SAN ANTONIO WATER SYSTEM
DSP Southeast Tank and Pump Station Project
SAWS Job Nos. 13-6102 (DSP) & 13-6005
Solicitation No. CO-00006

ADDENDUM NO. 3

August 10, 2015

1 PZ830 PUMP STATION TYPICAL SECTION
 PS-2 1/2" = 1'-0"

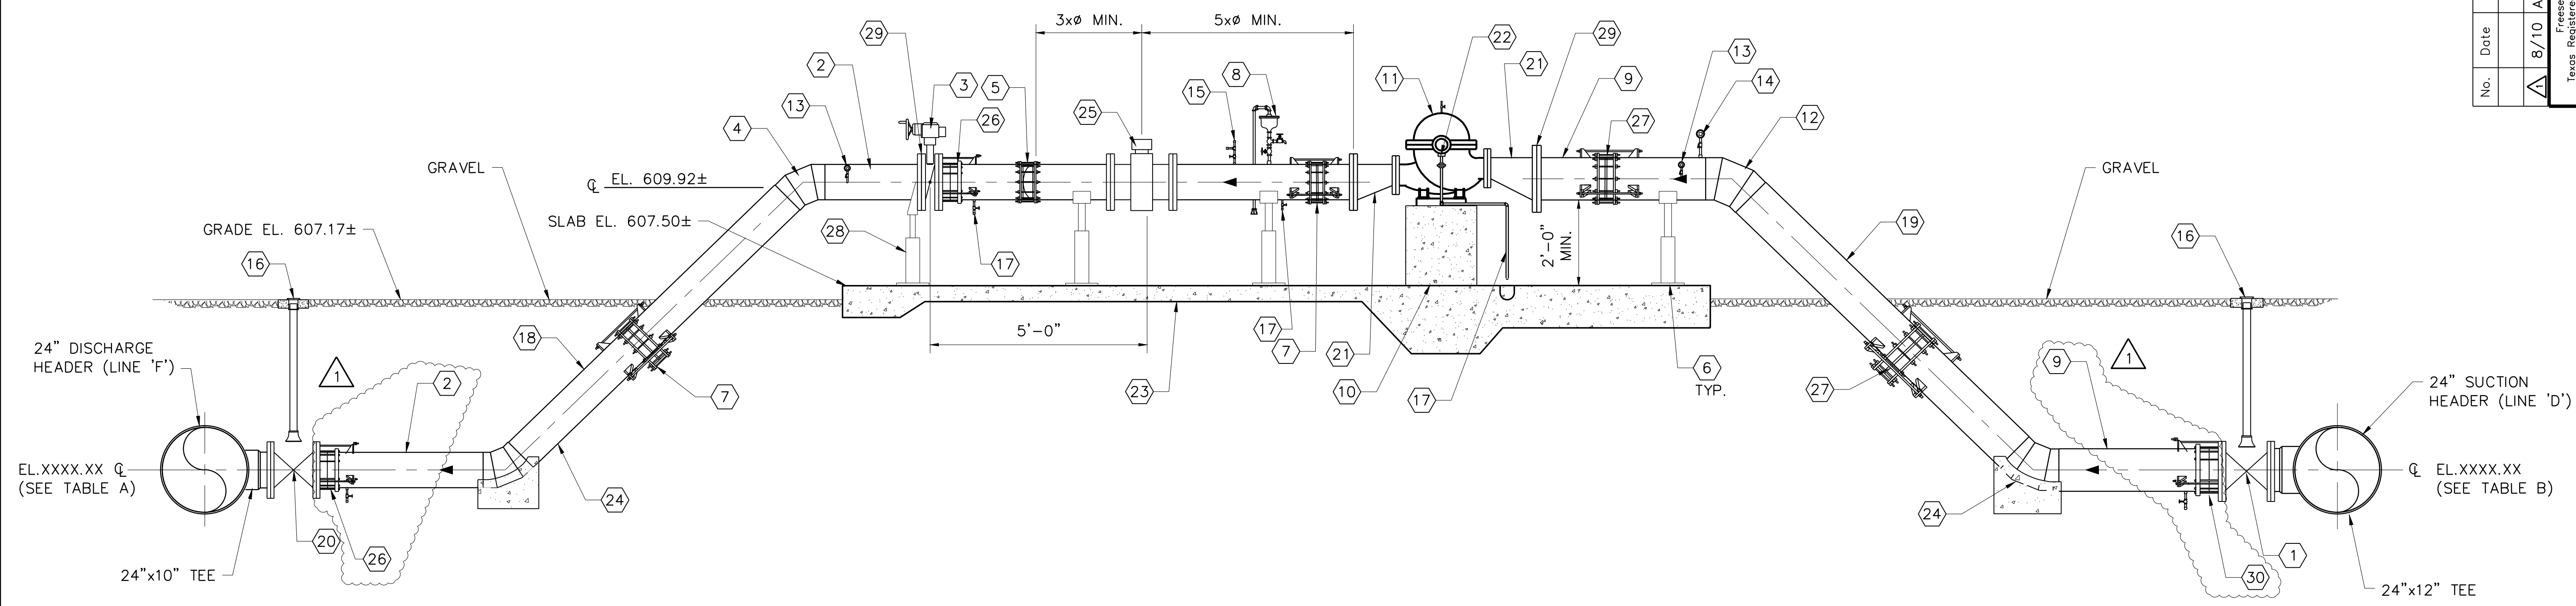
- 3. SHEET PS-3:

- a. REPLACE this drawing in its entirety with the attached drawing.

PS-4 PZ2 PUMP STATION TYPICAL SECTION
1/2" = 1'-0"

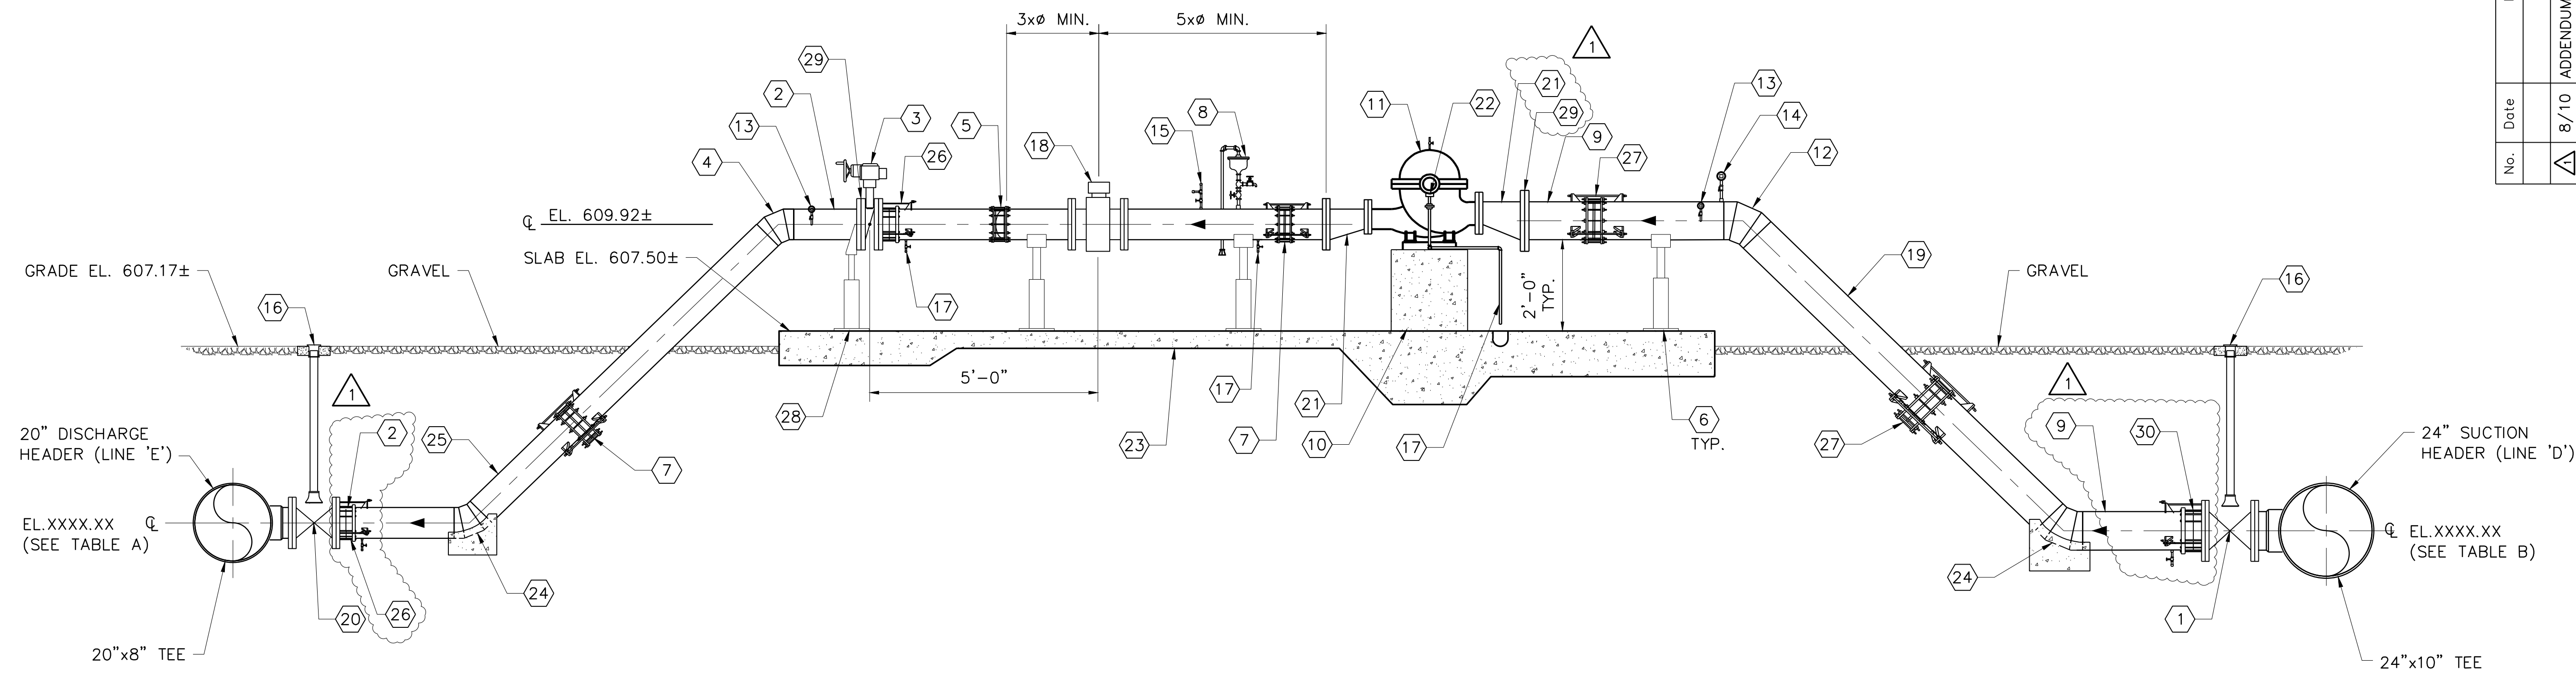
- 4. SHEET PS-5:

- a. REPLACE this drawing in its entirety with the attached drawing.
